TOLEDO-LUCAS COUNTY PLAN COMMISSIONS

REF: PUD-8007-19

SUBJECT: Request for a Planned Unit Development for "The Colony South" at 1901 & 2061 W. Central Avenue, 2918-2951 Jermain Drive, 2820-2835 Rathbun Drive & 3842, 3846, 3860 Monroe Street.

REVISED SITE PLAN - WEST

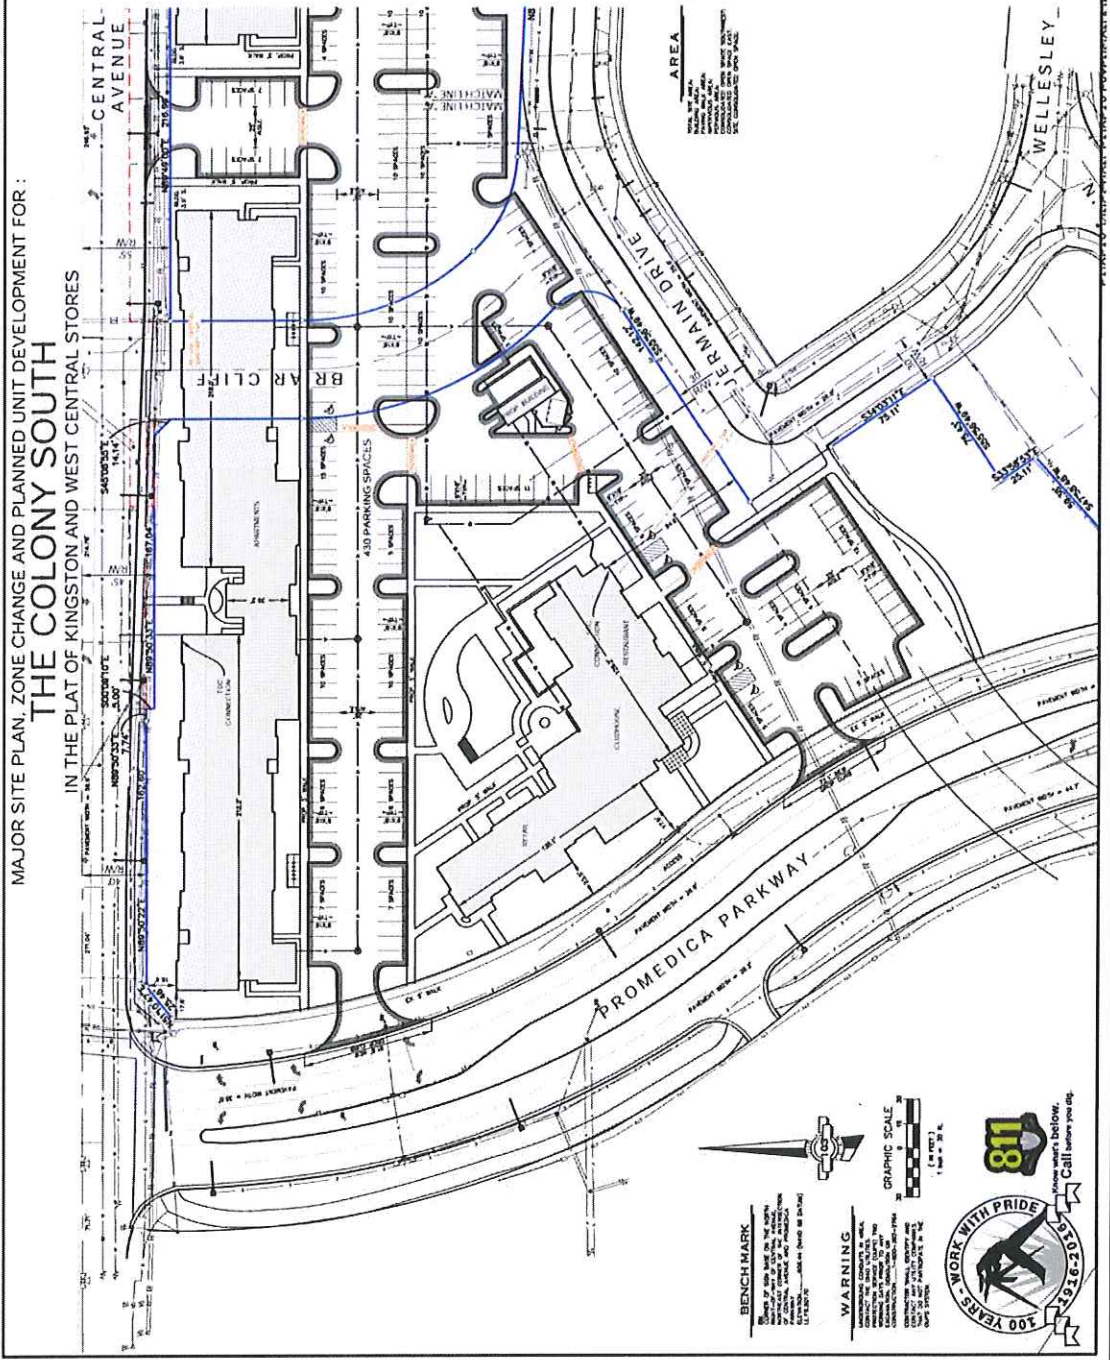
50. Pursuant to TMC§1103.1007(C), no more than forty-percent (40%) of gross site acreage shall be devoted to coverage by buildings, structures, street, driveway and parking area pavement. **Plan Commission supports a variance to TMC§1103.1007(C), for an increase of twenty-one percent (21%) of gross site acreage devoted to coverage by buildings, structures, street pavement, driveway, and parking area pavement.**

51. Per TMC§1103.1007(D), a PUD is required to provide fifteen-percent (15%) of gross site acreage for usable, accessible and consolidated open space, none of which is part of any required yard or perimeter open space. One-third (1/3) of this consolidated open space area may be used for detention/retention purposes. **Acceptable as depicted on revised site plan.**

52. Pursuant to TMC§1103.1007(E)(1), When abutting a Residential district, the open space perimeter area shall be provided with a minimum depth equal to the required rear yard setback of the PUD's underlying zoning district. **Plan Commission supports a variance to TMC§1103.1007(E)(1), for a twelve and one-half foot (12.5') reduction of the required perimeter open space area along the southern property lines to allow a nine and one-half foot (9.5') perimeter open space area.**

57. All spaces reserved for the use by persons with physical disabilities shall adhere to the standards outlined in TMC§1107.1700. A minimum of seven (7) auto and two (2) van accessible parking spaces are required for use by persons with physical disabilities. **Acceptable as depicted on revised site plan.**

58. Bicycle parking slots shall be provided pursuant to Off-Street Parking Schedule "A" (TMC§1107.0300), which requires one (1) bicycle parking slot per ten (10) parking spaces. Forty-three (43) bicycle parking spaces shall be provided on site. **Acceptable as depicted on revised site plan.**

REVISED LANDSCAPING PLAN - OVERALL

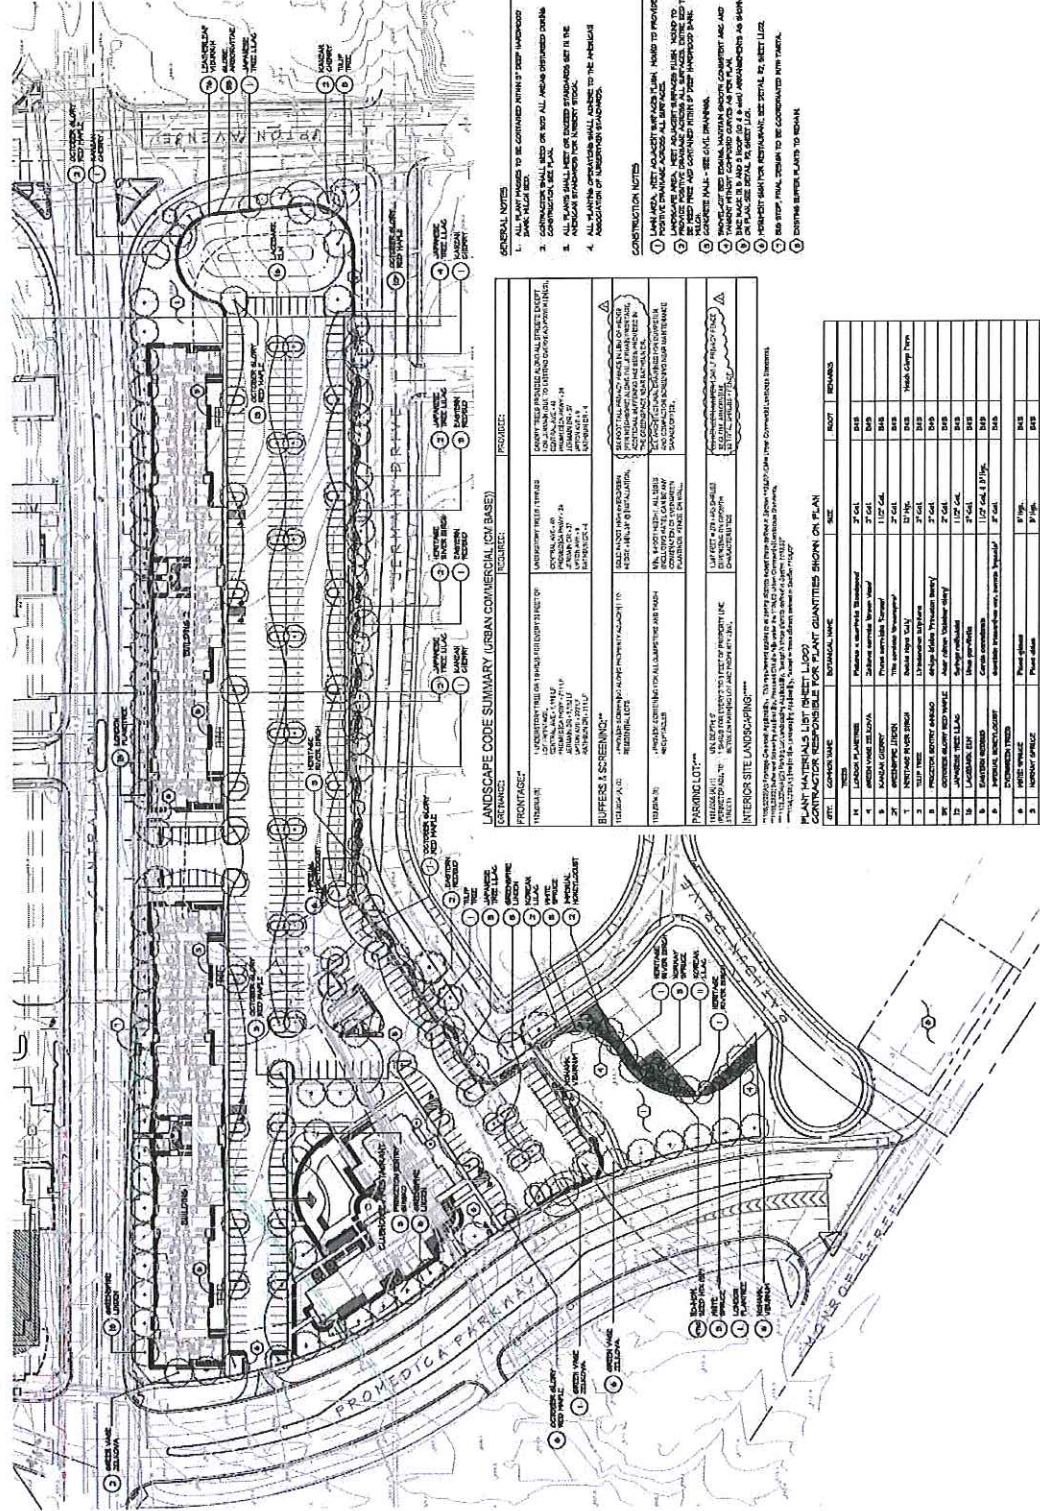
The revised landscaping plan submitted depicts a solid row of shrubs surrounding the entire perimeter of the parking lot. A six-foot (6') tall wood privacy fence with 90 shrubs and 37 trees is proposed along the southern boundary for the entire Jermain Drive frontage. Additional landscaping is depicted within the interior of the development at all buildings and the parking lot landscape islands in efforts to completely screen the site from the abutting residential properties to the south. The proposed landscaping for the perimeter and interior parking lot satisfy the requirements of the Urban Commercial Landscaping Standards.

Out of concerns from the neighbors, the applicant revised the landscaping buffer along Jermain Drive in order to add a six-foot (6') tall wood privacy fence in lieu of the solid evergreen hedge. Additionally, due to the installation of the fence and the request of the neighbors, pedestrian access to the restaurant from Jermain Drive is eliminated, which further separates the development from the residential neighborhood.

- b. Per TMC§1108.0304(A), a solid six-foot (6') high evergreen hedge, with minimum plant height at installation of at least three-feet (3'); or a masonry wall or fence with a minimum height of six-feet (6'), with no openings; shall be installed to provide screening from the adjacent residential lots. **Acceptable as depicted on revised landscaping plan.**

- c. Perimeter landscaping must be installed along any parking lot area adjacent to a street, place, or driveway in accordance with the Urban Commercial Landscape Standards in TMC§1108.0300. **Acceptable as depicted on revised landscaping plan.**
